Prairie Island Nuclear Generating Plant Units 1 and 2
Dockets 50-282 and 50-306
License Nos. DPR-42 and DPR-60

Response to Requests for Additional Information (RAI) Associated with Adoption of the Alternative Source Term (AST) Methodology (TAC NOS. ME2609 and ME2610)

Nuclear Regulatory Commission (NRC) Request for Additional Information (RAI)

Figure 7: SG Steam Releases

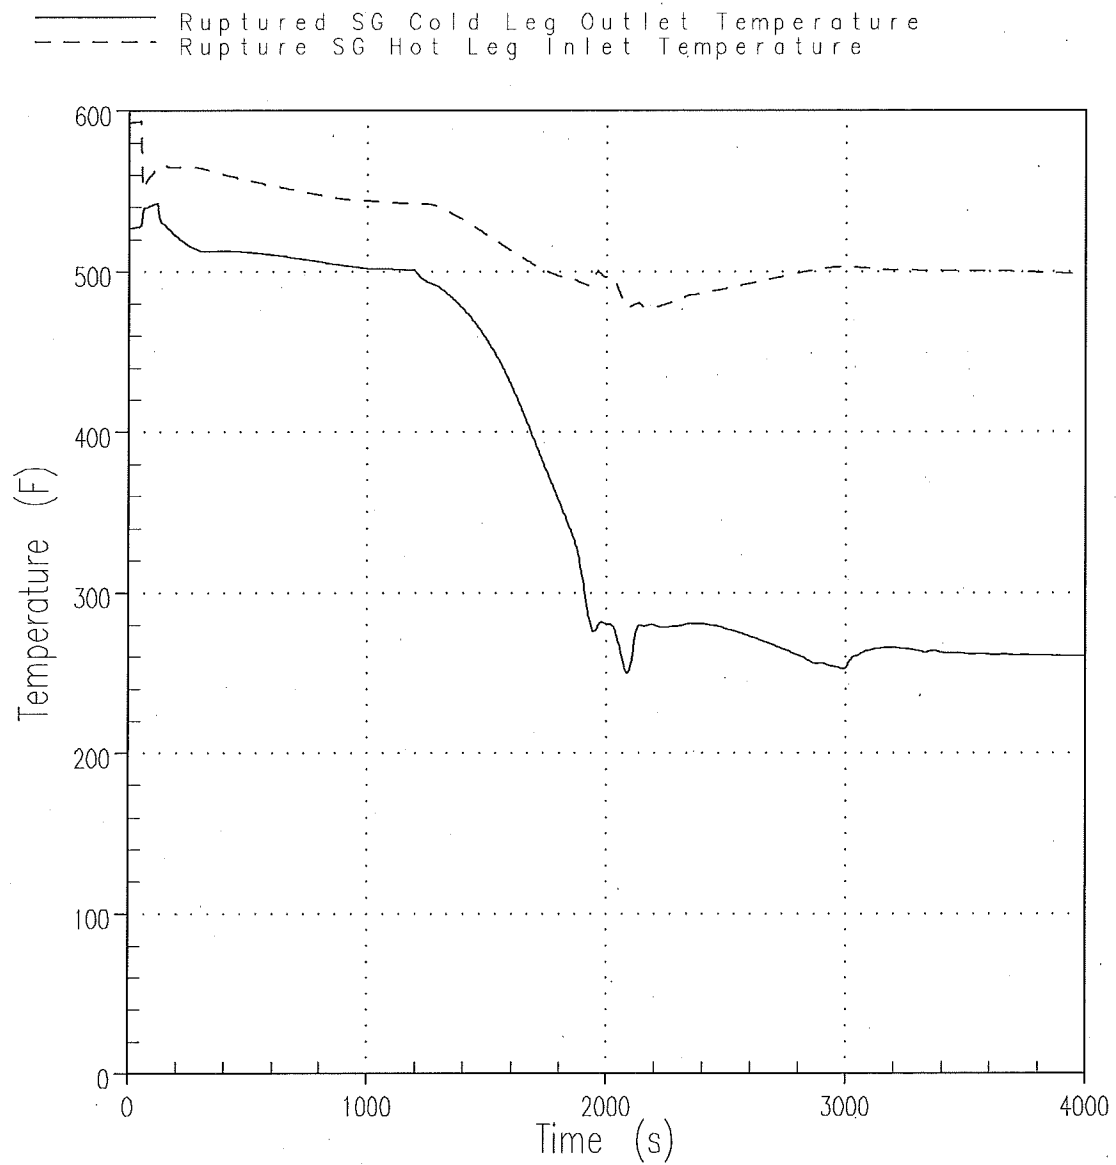
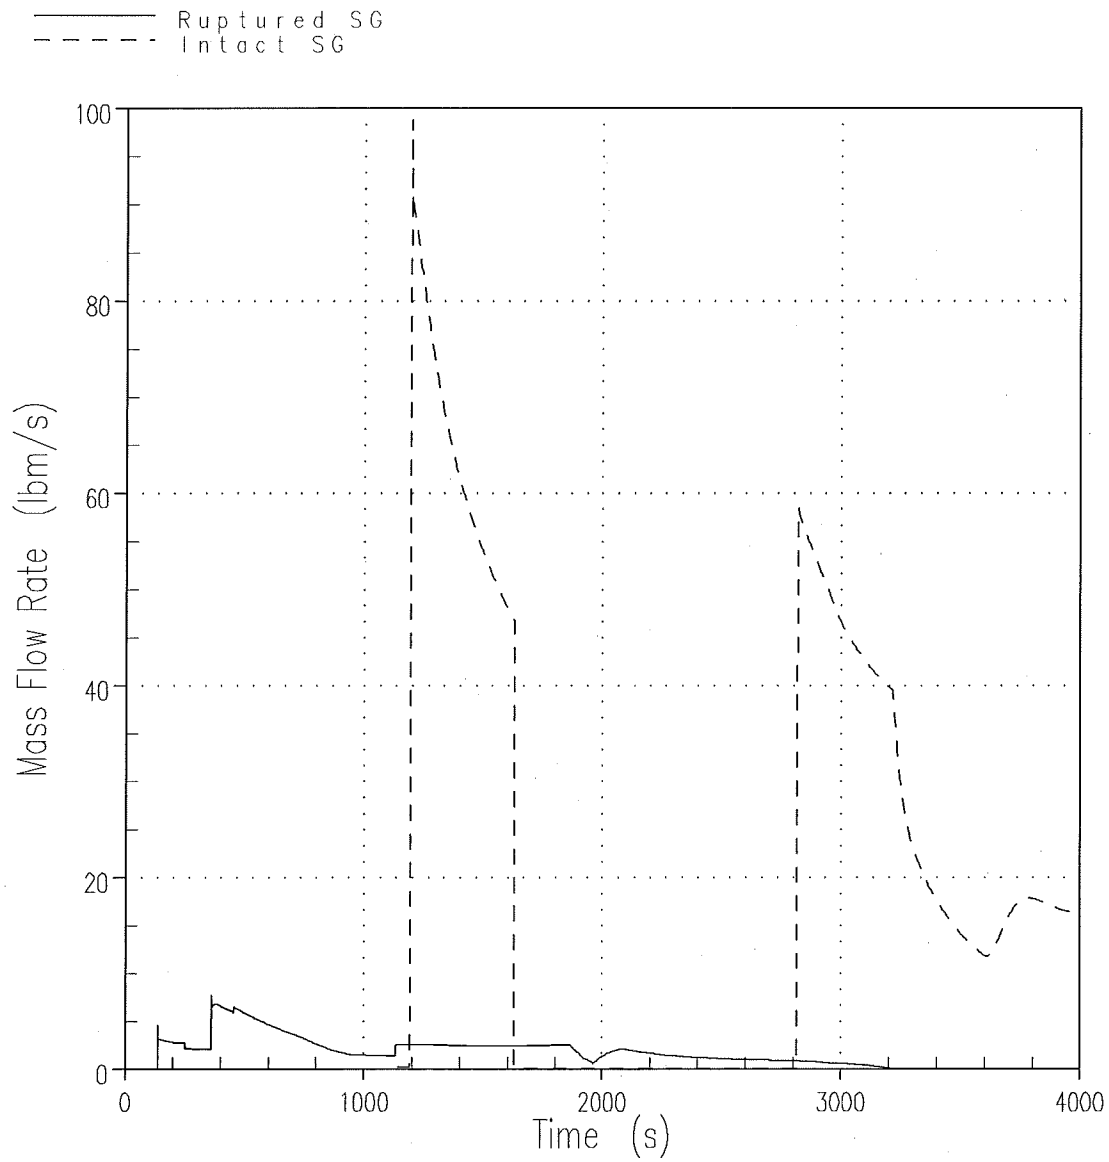
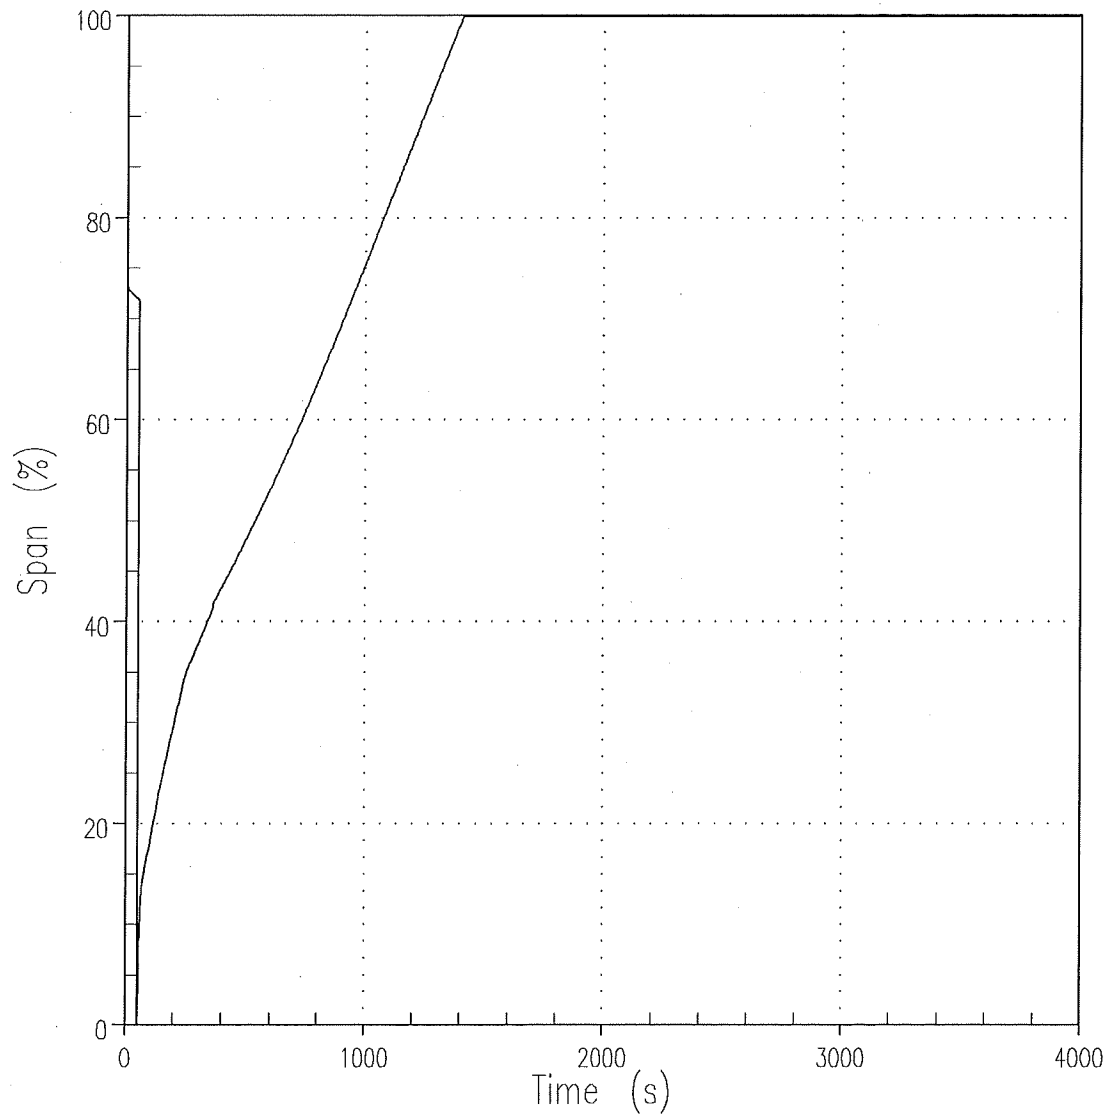
- A.2 *Alternatively, the licensee may perform an SGTR MTO analysis for PINGP at current licensed thermal power conditions. The analysis should align as closely as possible to an NRC-approved methodology described in a Westinghouse topical report, WCAP-10698-P-A. However, since the licensee has stated that a limiting single failure is not in the PINGP licensing basis, this exception to the WCAP-10698-P-A methodology will be acceptable. The requested analytical results should include sequences of the event with specification of operator actions and the associated times credited in the analysis, and the response of key plant parameters versus time.*

NSPM has performed sensitivity analyses to determine the limiting margin-to-overfill (MTO) scenarios at 1683 MWt, which is the current licensed reactor core power level of 1677 MWt, plus calorimetric uncertainties. The analyses followed the methodology in WCAP-10698-P-A, with the exception of the assumption of a single failure.

The results indicate a margin-to-overfill of 186 ft³ in the ruptured steam generator for the limiting scenario. The limiting scenario models 0% steam generator tube plugging (SGTP), low decay heat, maximum safety injection (SI) enthalpy and minimum auxiliary feedwater (AFW) enthalpy. No water is transferred into the steam lines.

The sequence of events for the limiting scenario analysis is presented in Table 1. Figures 1 through 8 provide the time-dependant values of the following parameters for the limiting MTO scenario:

Figure 9, Page 1
Unit 1 Power Level and Steam Generator
Narrow Range Water Level

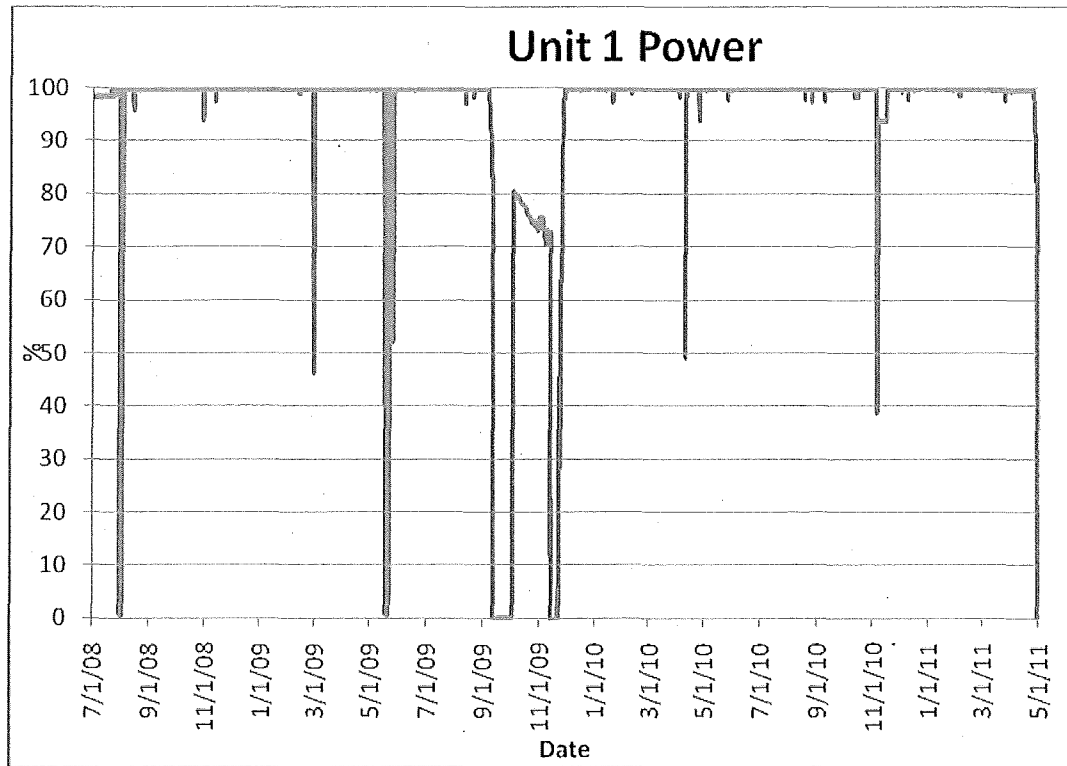
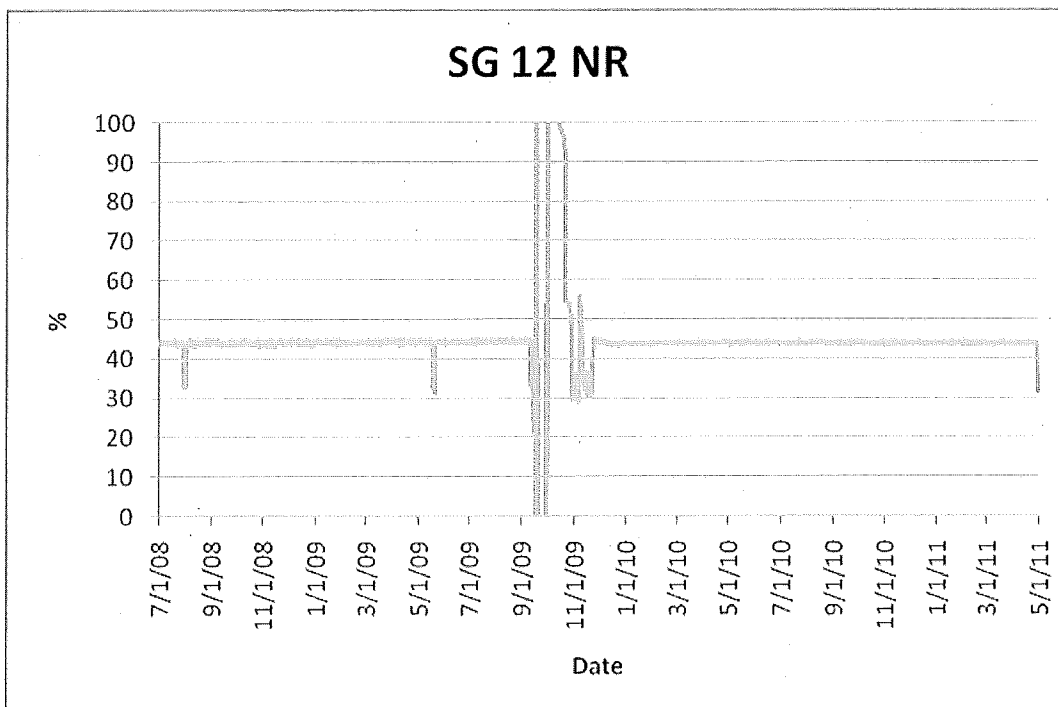
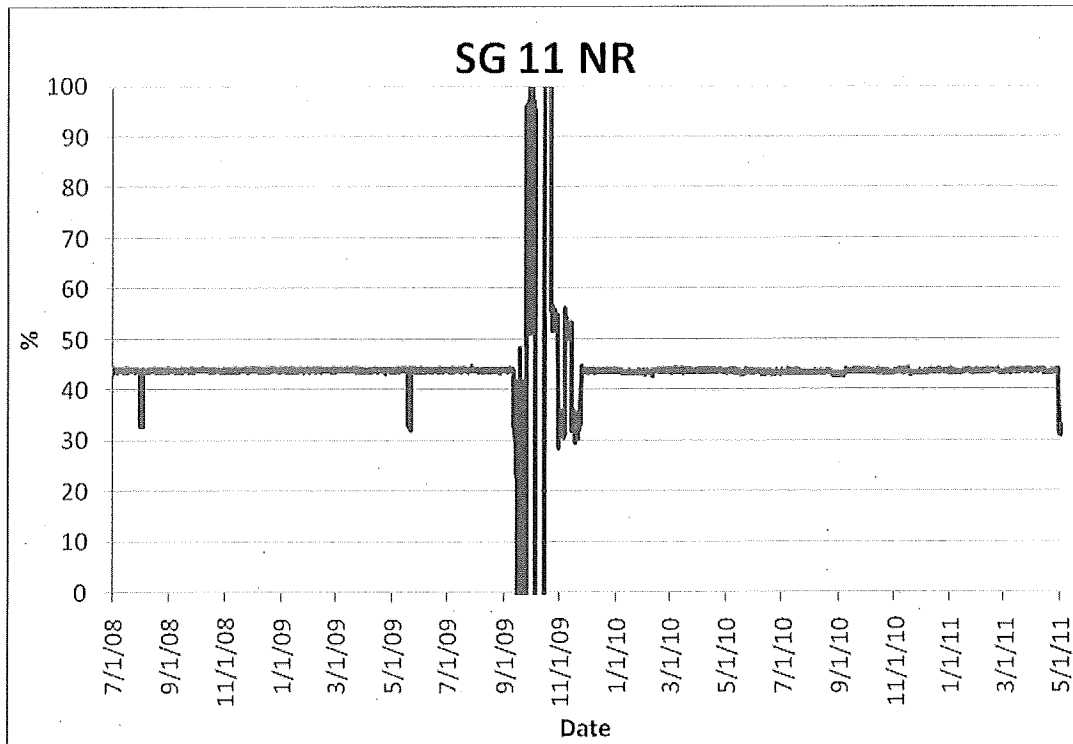
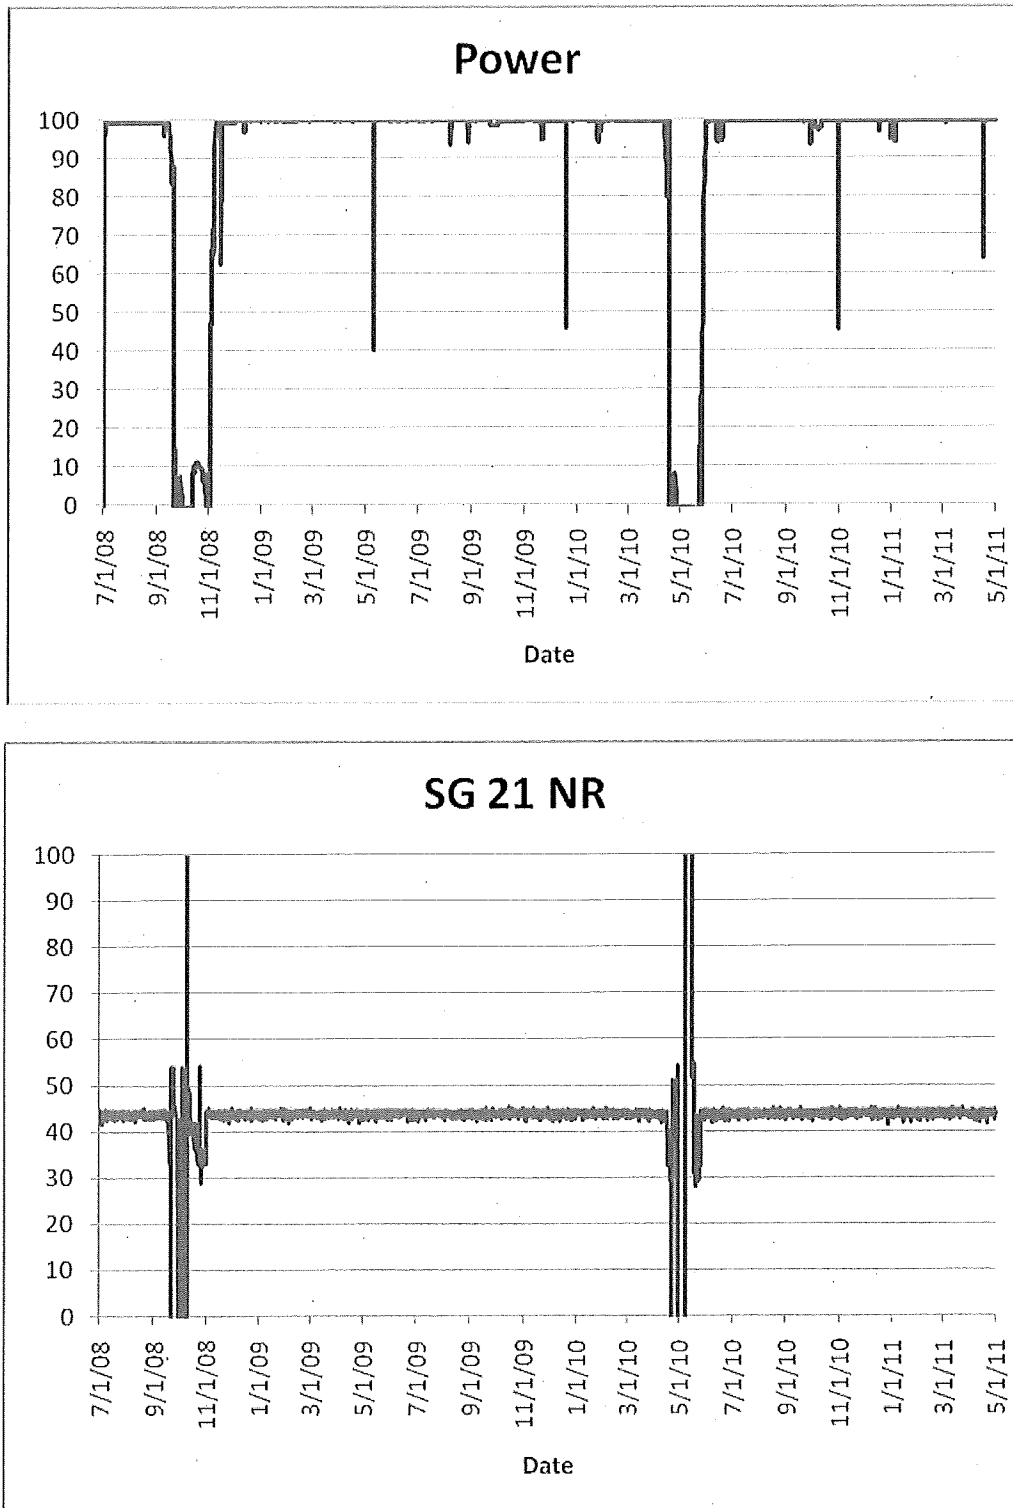
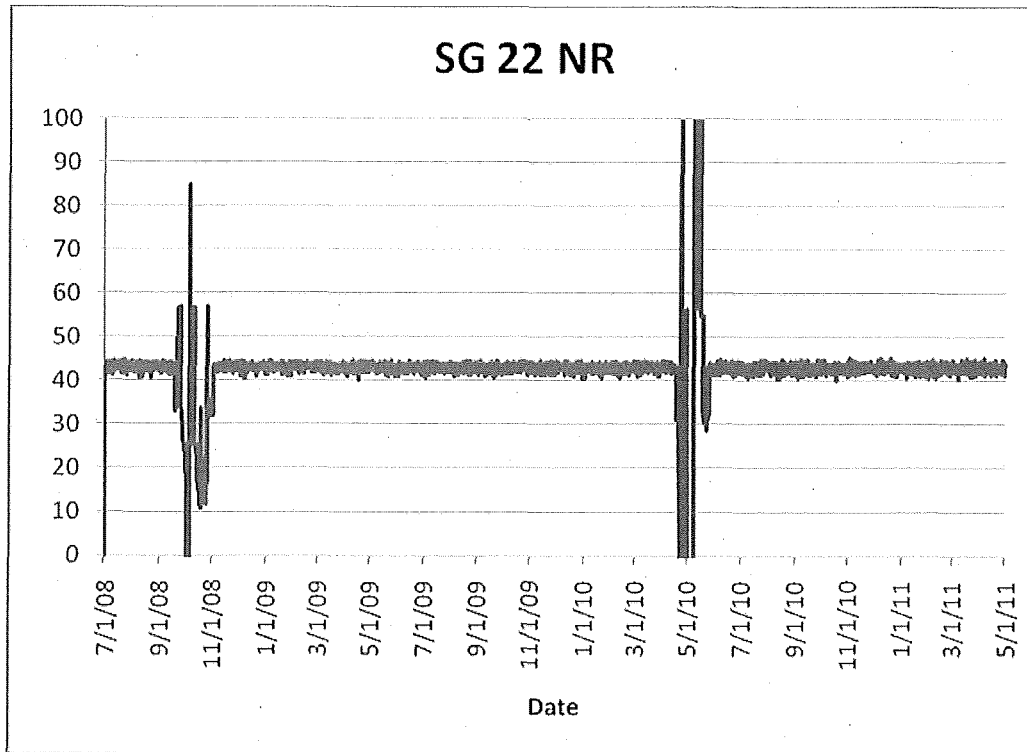
A.2.e *One of the key parameters that will affect the results of the SG MTO analysis during an SG tube rupture event is the initial SG water level, which is a function of the initial power level. The MTO analysis to be submitted should consider the effects of initial SG water levels corresponding to power levels that capture 95 percent of the operating time during a fuel cycle. Also, for the range of power levels that envelop 95 percent of operating time, provide trending data for the corresponding SG water levels to show that conservative initial SG water levels (with the inclusion of measurement uncertainties, thus resulting in a smaller margin to SG overfill) have been selected.*

PINGP operates at power levels of approximately 100% for more than 95% of the operating time during a fuel cycle. The data shown on the attached Figure 9 for Unit 1 and Figure 10 for Unit 2 represents the time period of July 2008 through May 2011. On Figure 9, the entire time period of early September to late November 2009, the reactor was shutdown.

The 100% power nominal setpoint for steam generator level control is 44% narrow range. Steam Generator narrow range water level data for both Unit 1 and Unit 2 was reviewed for the same time period used in Figures 9 and 10 for displaying power. The data is shown on the attached Figures. For each Unit a Figure is provided for each Steam Generator indicated narrow range water level for the same periods of time that are shown in Figures 9 and 10 for the power levels. As shown in the Steam Generator water level plots, during full power operation, the water level varies from the program level by a small amount. The data shows that this variance is less than +/- 1% indicated level. As shown on Table 3, included as part of the response to RAI A.2.b, above, an assumed initial SG narrow range water level of 73% is used in the MTO analysis. It is noted that the 73% initial SG water level includes accounting for the turbine runback. Thus, actual steam generator indicated level for 100% steady state power operation is bounded by the initial SG water level assumed in the analysis.
